PROGRAM INFORMATION BULLETIN NO. P08-17

SUBJECT: Potential Boom Failure on Komatsu America Corp. Model
PC400LC-7L Excavator

CAMPAIGN NUMBER: 7C064 1

SUBJECT: PC400LC-7L REPAIR OF ARM CYLINDER BRACKET ON BOOM. ***NOTE:
EXTENDED COMPLETION DATE 6/27/2008 KF***

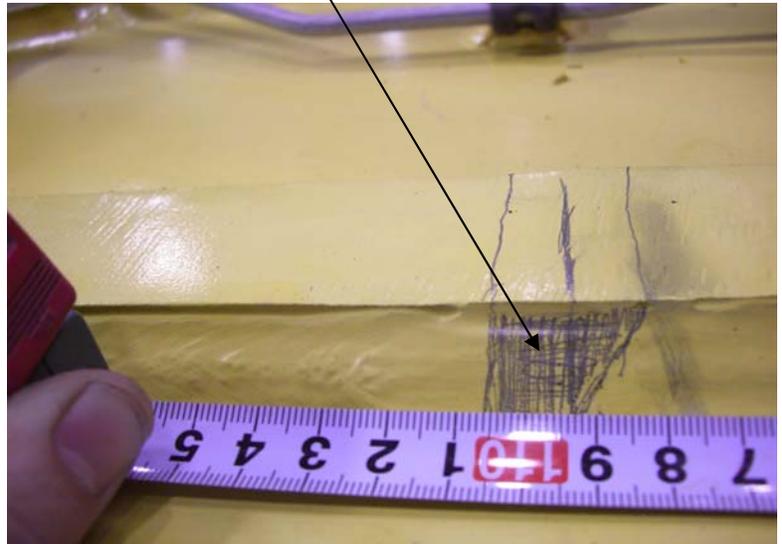
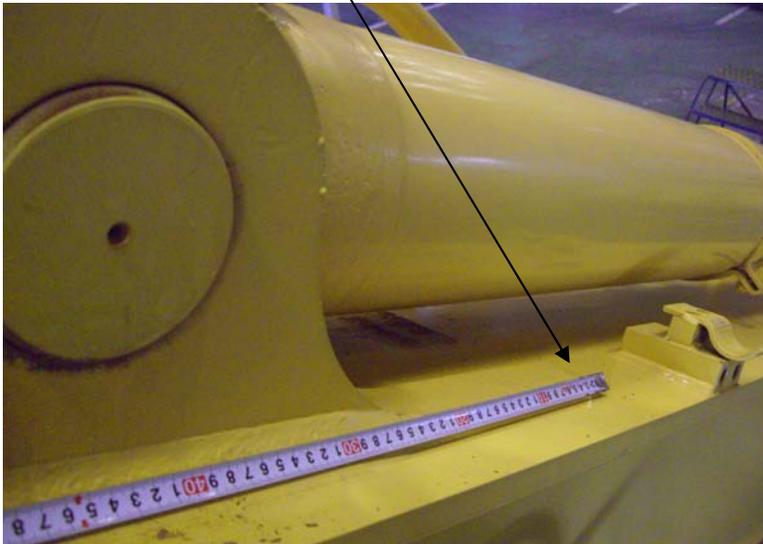
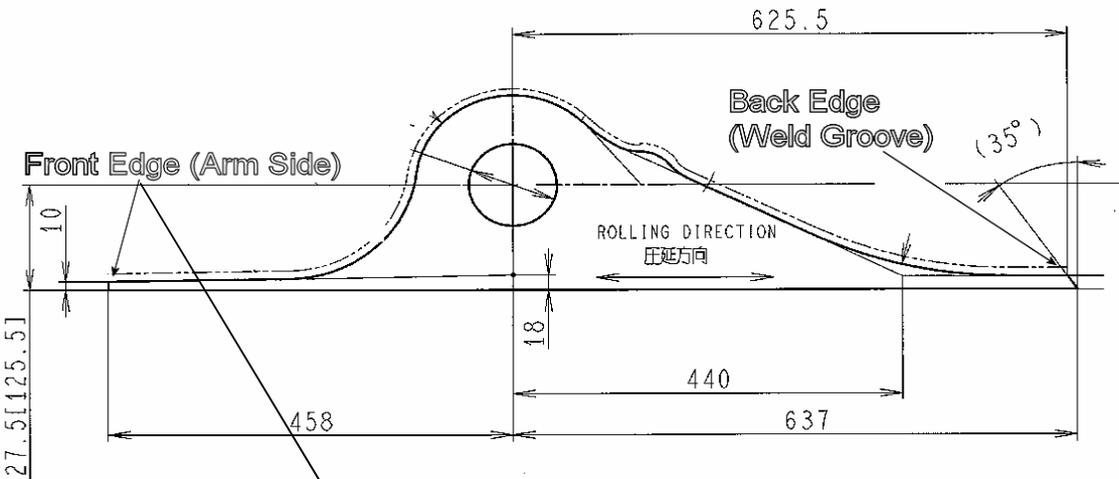
1. Place the machine on level ground and lower boom to lowest possible position.
See Photo 1

3. Without breaking any hydraulic connections, pull tubes off to side of boom and band tie together to make access for weld repair. See Photo 2.

4. Layout and mark area to be ground out.

If there is no visible crack, weld root is 1095 mm from front edge of bracket.

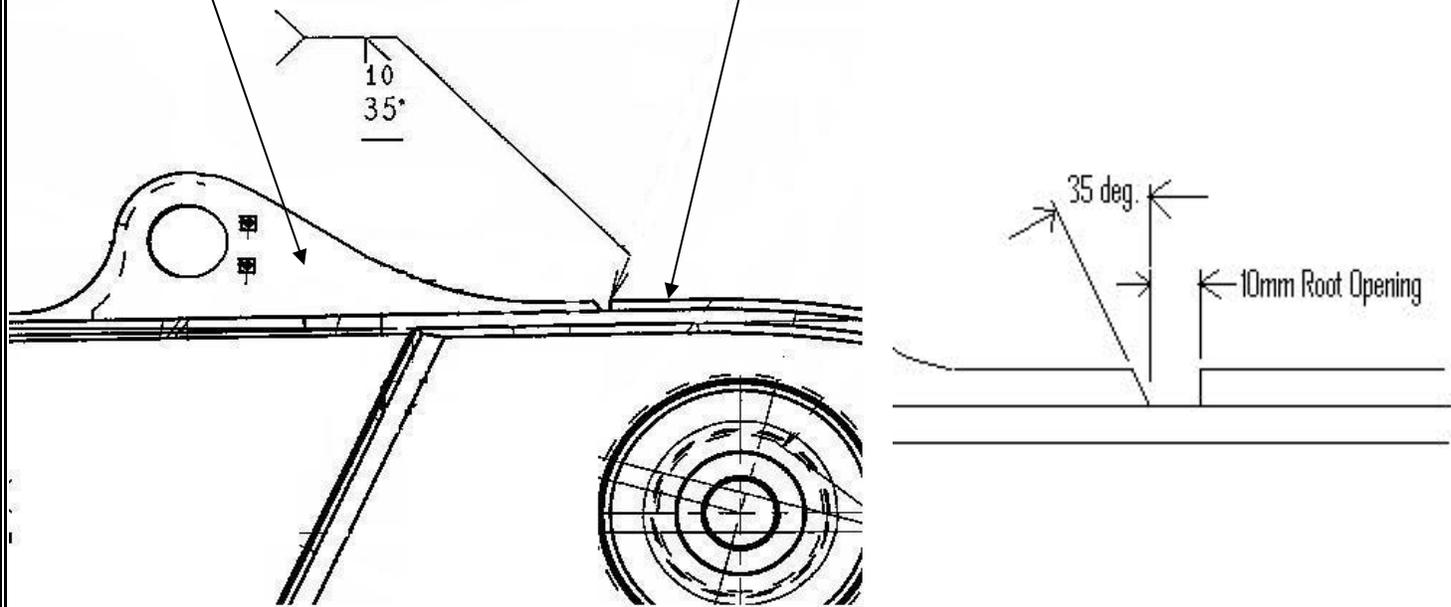
6. Liquid penetrant (PT) inspect weld groove to ensure top plate is not cracked. *Note: Dye will bleed out between cyl. bracket and top plate and between reinforcing strip and top plate as shown; Check is to ensure there is no crack in fillet welds at side of bracket or in the boom top plate.*
If cracking has occurred in top plate; See page 4/5 for additional instructions.

7. Clean weld groove and weld per page 6 procedure.

8. Grind and paint as shown, reassemble tubes to boom.

1. Air arc or grind out entire crack 16mm deep including 5mm on each side into sound base metal. Include 35 deg. Bevel.
2. Liquid penetrant (PT) or Magna Flux (MT) inspect weld root area to ensure crack has not progressed into boom top plate.
3. Weld per procedure on page 6.
4. Grind weld cap pass flush with bracket and blend ends of weld with existing fillet weld.
5. Recommended (but not mandatory) UT inspection of finished weld to ensure there is no lack of fusion.
6. Paint.
